## **SkyStar Aircraft Corporation**

**SERVICE BULLETIN # 25**

**SUBJECT: MODEL IV STYLE FLAPERONS**

**TO: ALL KITFOX BUILDERS WITH MODEL IV WINGS (laminar flow wing)**

FLAPERON HORN AND BEARING ASSEMBLY FOR FLAPERONS WITH INCORRECTLY SLOTTED SKINS.

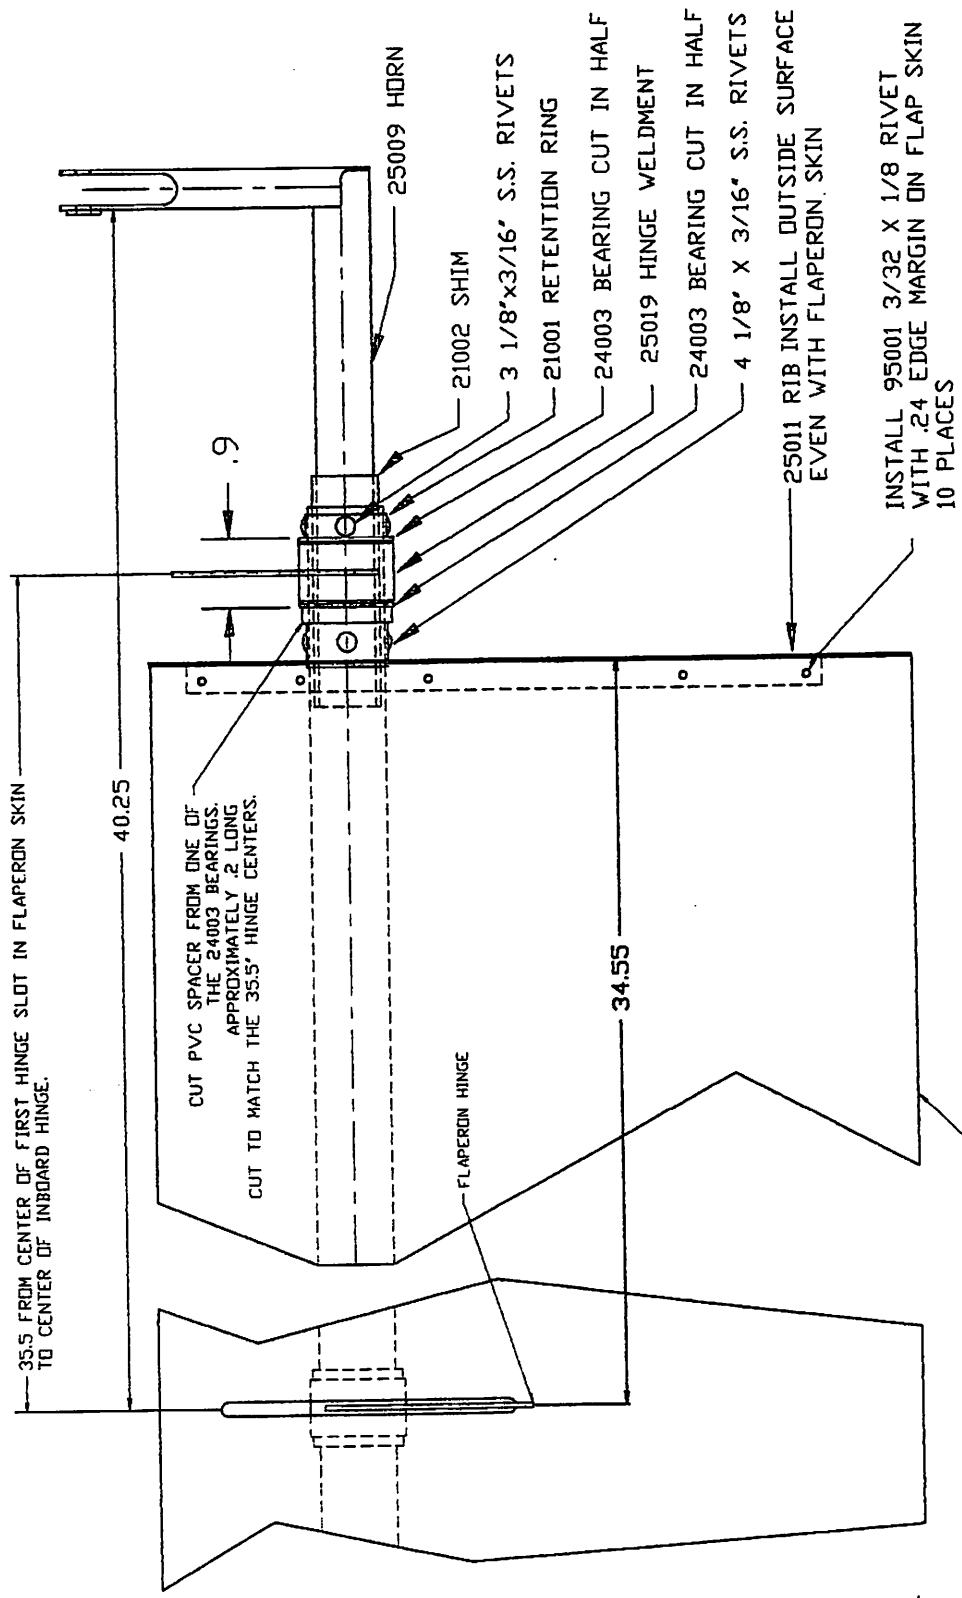
It has come to our attention that there was a period of time that the Model IV flaperons might have been inadvertently cut .2" short on the inboard end. If the flaperon control horn is attached per the Manual instructions, on one of these "short" flaperons, then it is possible that the inboard flaperon hinge will not match up to the flaperon attach bracket on the # 1 rib or have the proper distance from the first inboard hinge (35.5"), refer to the enclosed drawing.

The way to determine if your flaperons fall into this "short" category, is to measure the distance from the center of the first hinge cut out to the inboard end of the flaperon skin. **The measurement from the center of the first hinge slot to the inboard edge of the flaperon skin should be 34.55".**

If you find that you have one of these "short" flaperons and have not attached the #25009 Flaperon Control Horn, cut a .2" piece of #24003 Bearing (scrap from the cut off section of bearing) and install it between the #25011 End Rib bushing and the #24003 Bearing, per the enclosed drawing.

**If you have already assembled your Flaperon Control Horn to the flaperon and you find that your flaperon is "short",** please call one of our customer service representatives so that we can send you two off-set flaperon hinges (off-set by .2") and a new set of #25009 Flaperon Control Horns, to take the place of those you will need to replace. You will have to drill out the rivets that attach the #21001 Retention Ring to the Control Horn and the Control Horn to the end rib. Replace the hinge and rivet the Retention Ring and new Control Horn back into place on each flaperon.

35.5 FROM CENTER OF FIRST HINGE SLOT IN FLAPERON SKIN TO CENTER OF INBOARD HINGE.

CUT PVC SPACER FROM ONE OF THE 24003 BEARINGS. APPROXIMATELY 2 LONG CUT TO MATCH THE 35.5" HINGE CENTERS.
